CONSTRUCTION SUMMARY

Summer Ridge Estates Inc.

LOT NUMBER	PHASE	HOUSE TYPE	CLOSING DATE
028 BLOCK 292	1	FRENCH ROSE (25-04 A 4) ELEV A 4 BEDROOM	04-Feb-26

Invoice Number: 8790

Cable - (x2)
Telephone - (x2)
conduit (x1)

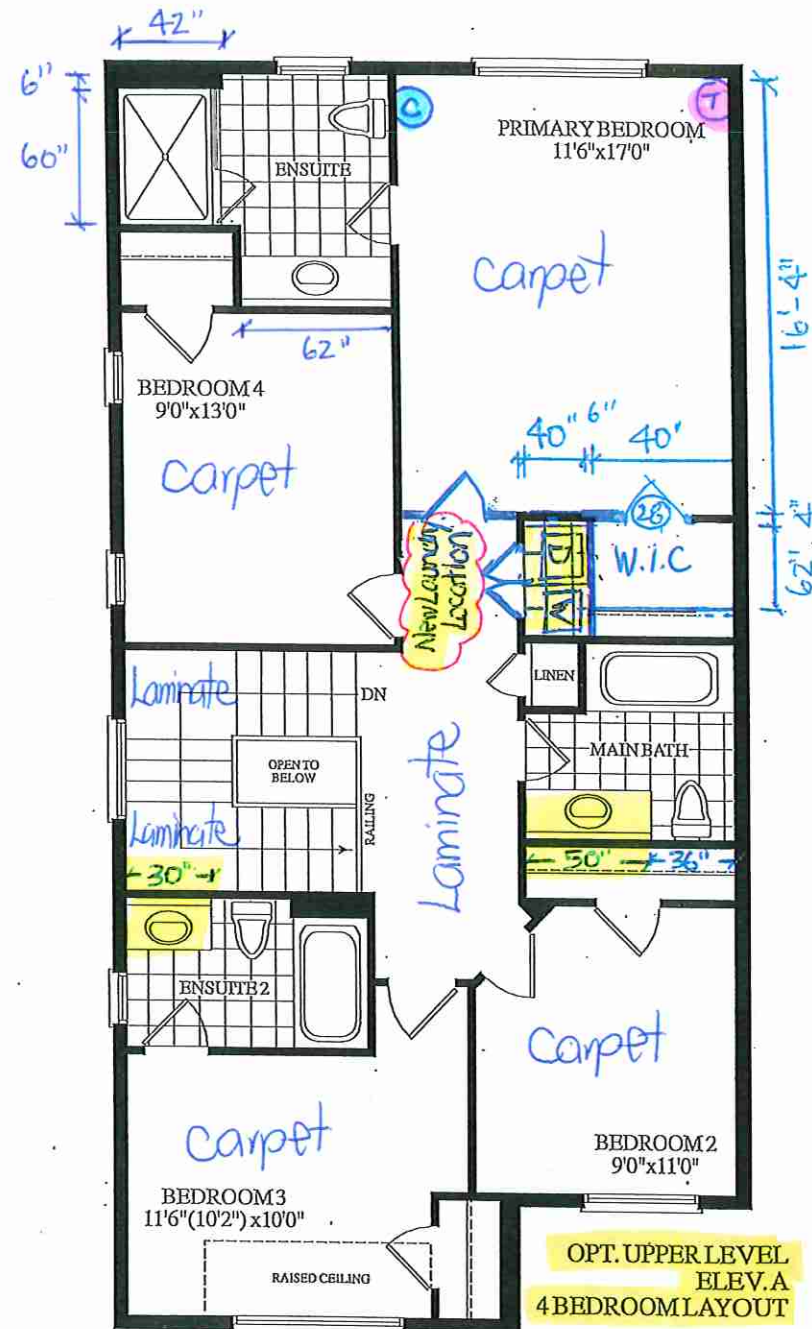
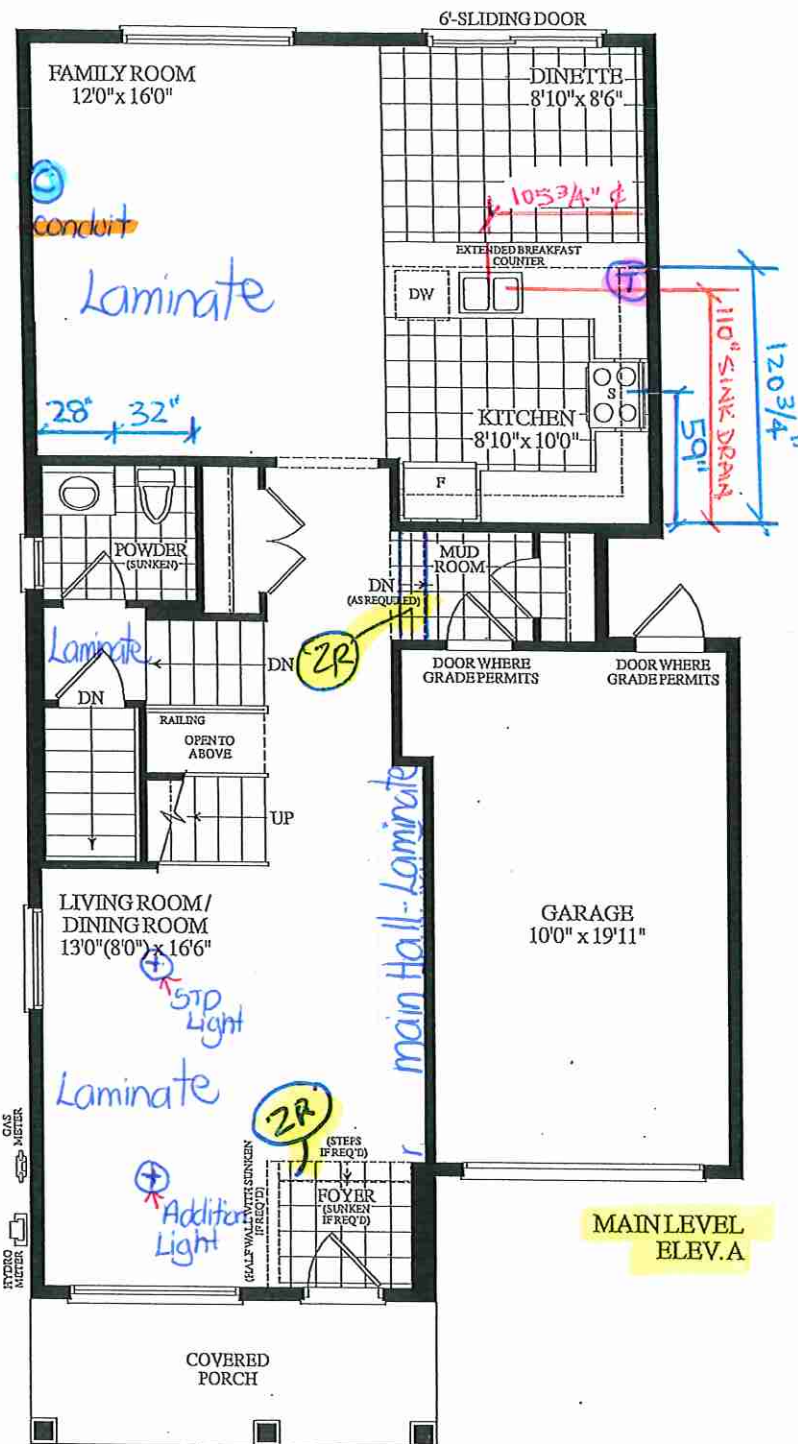
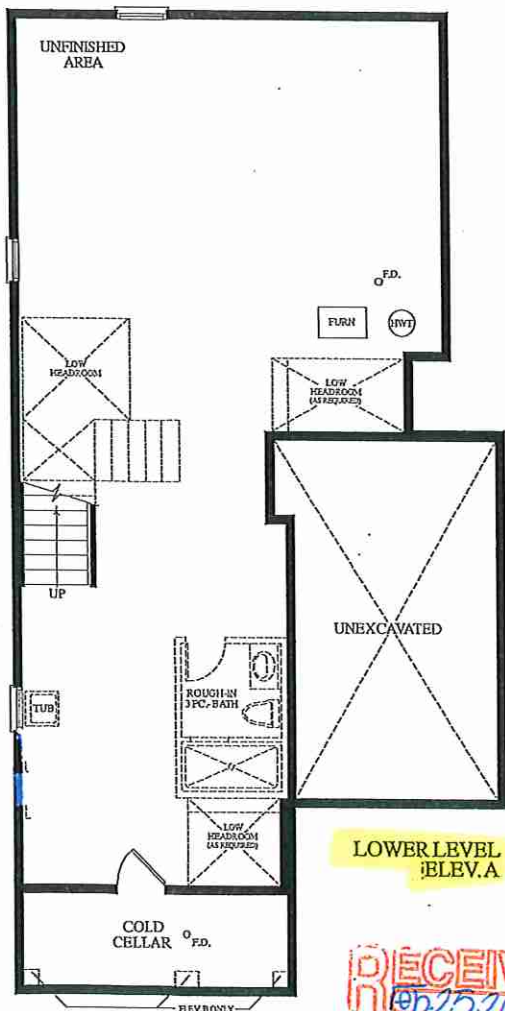
1 - Install Standard Cable Rough-Ins (x2) and Install Standard Telephone Rough-Ins (x2) (See Sketch)

1 - LIVING ROOM - In addition to builders standard switch operated plugs, Install ONE (1) CEILING LIGHT Controlled by ONE (1) Seperate Switch at living room. Additional light to be installed inline with standard ceiling light at dining room (See Sketch)

1 - MAIN FLOOR & UPPER HALL - FLOORING - Purchaser request to DELETE the builders standard 3 1/4" x 3/4" Red Oak Natural Hardwood Flooring, throughout all standard areas on main floor & upper hall. (See Sketch)

1 - MAIN FLOOR & UPPER HALL - FLOORING - Install LAMINATE Flooring - 7 1/2" TORLYS HIGHLAND WATSON NATURAL OAK EEH-292 - To be installed throughout main floor and upper hall where applicable.

1 - STAIRCASE - Stain Oak Staircase from Main Floor to Second Floor, where applicable. To be Stained - Mirage Red Oak DRIFTWOOD - To Include; Treads, Risers, Handrail and Post, where applicable (See Sketch)
